UNITED STATES PATENT AND TRADEMARK OFFICE

APPLICATION NO.	FILING DATE	FIRST NAMED INVENTOR	ATTORNEY DOCKET NO.	CONFIRMATION NO.
10/575,860	01/25/2007	Kyu Young Kim	K-0800	6863
34610 7590 09/25/2008 KED & ASSOCIATES, LLP P.O. Box 221200 Chantilly, VA 20153-1200				
EXAMINER				
LEUNG, PHILIP H				
ART UNIT		PAPER NUMBER		
3742				
MAIL DATE		DELIVERY MODE		
09/25/2008		PAPER

Office Action Summary

DETAILED ACTION

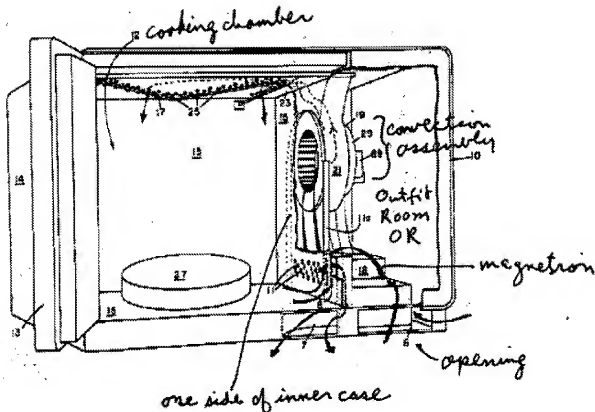
5. Claims 2, 6 and 21 are rejected under 35 U.S.C. 103(a) as being obvious over Klapper (DE 31 35 290 A1), in view of Larsen et al (US 4,332,992) (previously cited).

Klapper shows a microwave oven 2, comprising a body forming an outer appearance; an inner case in the body having a cooking chamber 1 formed therein, the inner case having a pair of side walls 15, a rear wall, and top and bottom walls; an outfit room 19 provided at one of the pair of side walls of the inner case, the outfit room having a plurality of electric parts (such as fan 11, motor 14, heating element 12) mounted therein; and a convection assembly mounted at one of the pair of side walls 15 of the inner cases that transmits heat to the cooking chamber 1, wherein the convection assembly comprises: a convection heater 12 configured to generate heat for convection heating; and a convection fan 11 configured to transmit the heat generated by the heater to the cooking chamber, and wherein the convection heater is positioned adjacent the convection fan (see Figures 1 and 2 and the English abstract). Therefore, Klapper shows every feature as claimed except for the location of the magnetron and the transformer being in the outfit room. Larsen shows a microwave oven comprising: a body 10 forming an outer appearance; an inner case 15 in the body having a cooking chamber 12 formed therein; an outfit room (marked as OR) at one side of the inner case, having various electric parts, (including a magnetron 18, a high voltage transformer 92), mounted therein; and a convection assembly (19, 21, 29) mounted at a side of the inner case, for transmitting heat to the cooking chamber and a convection heater 17 for generating heat for convection heating (see the marked-up copy of Figure 1 below).

It would have been obvious to an ordinary skill in the art at the time of invention to modify Klapper to locate the magnetron and transformer together with the convection assembly including the convection fan so that the oven enclosure can be more compact and the heat generating components, such as the magnetron and the transformer can be more effectively cooled, in view of the teaching of Larsen.
